# Technical Service Bulletin

No.LTB00241  
29 October  
2009

<b>Subject/Concern :</b> Front Suspension Knock Improvement
---

<b>Models :</b>		
Range Rover Sport (LS)	Vehicles With Dynamic Response	Vehicles With Dynamic Response VIN- range : 983118 Onwards

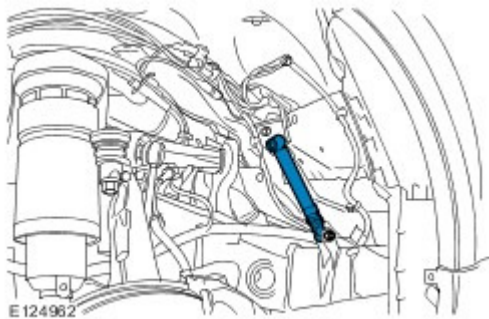
- 1 . Raise vehicle on a suitable ramp (see Global Technical Reference GTR Workshop Manual, section 100-02 - Lifting).
- 2 . Reposition road wheel to gain access to splash shield top grommet (arrow 1 in E124853).
  - 1 . Remove splash shield top grommet.

- 3 . **NOTE :** Front left-hand body mount damper shown with splash shield removed for clarity, right-hand body mount damper similar.

If installed, remove front body mount damper and discard.

- 1 . Remove top and bottom body mount damper fixings (access gained through splash shield - arrowed 1 and 2 in E124853) and withdraw damper.
